- SQSS modification GSR029 Review SQSS section 3 to align with EREC P2/7
- 2. Grid Code changes required

SQSS modification GSR029

Group Demand Calculation – Proposed Changes

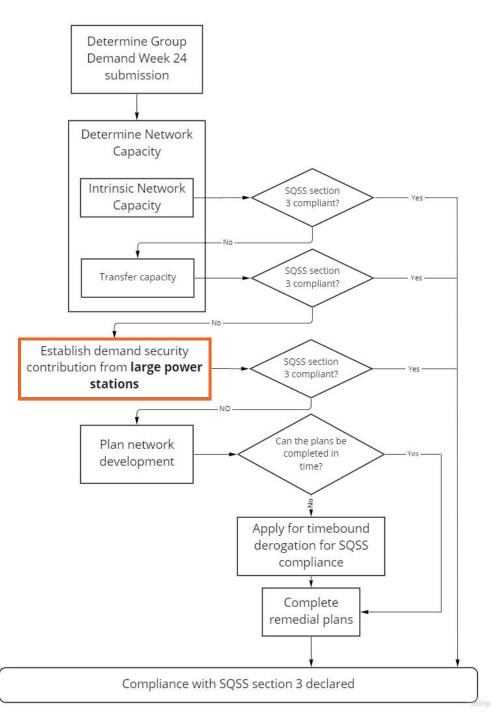
210MW

10MW

100MW

-10MW

Demand Security Contribution Calculation Proposed Changes

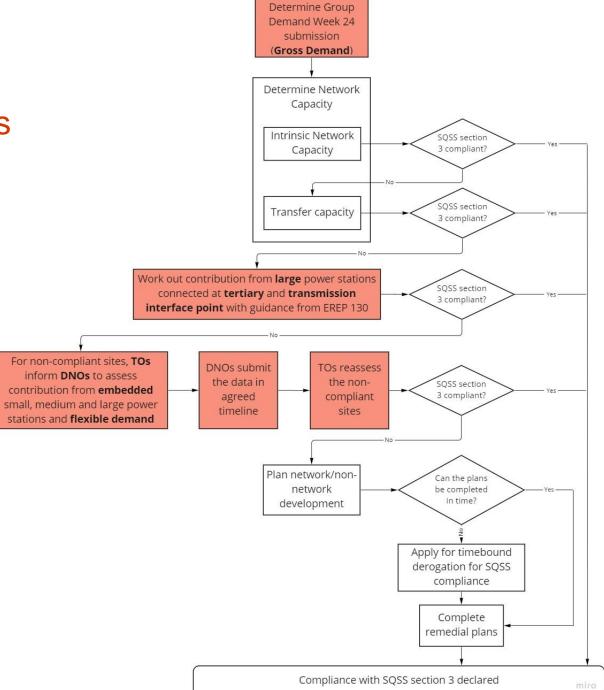
- Change the **definition of** *Group Demand* in clause 3.5;
- Introduce a definition of Flexible Demand;
- Revise the background conditions specified in 3.7.3 and 3.7.4 to make it clear that the demand security contribution from embedded small and medium power stations, Demand Side Response, Energy Storage and Active Network Management scheme need to be considered;
- Remove Table 3.2 and replace with the reference to EREP 130 as guidance to assess the effective contribution of embedded large power stations to demand group;
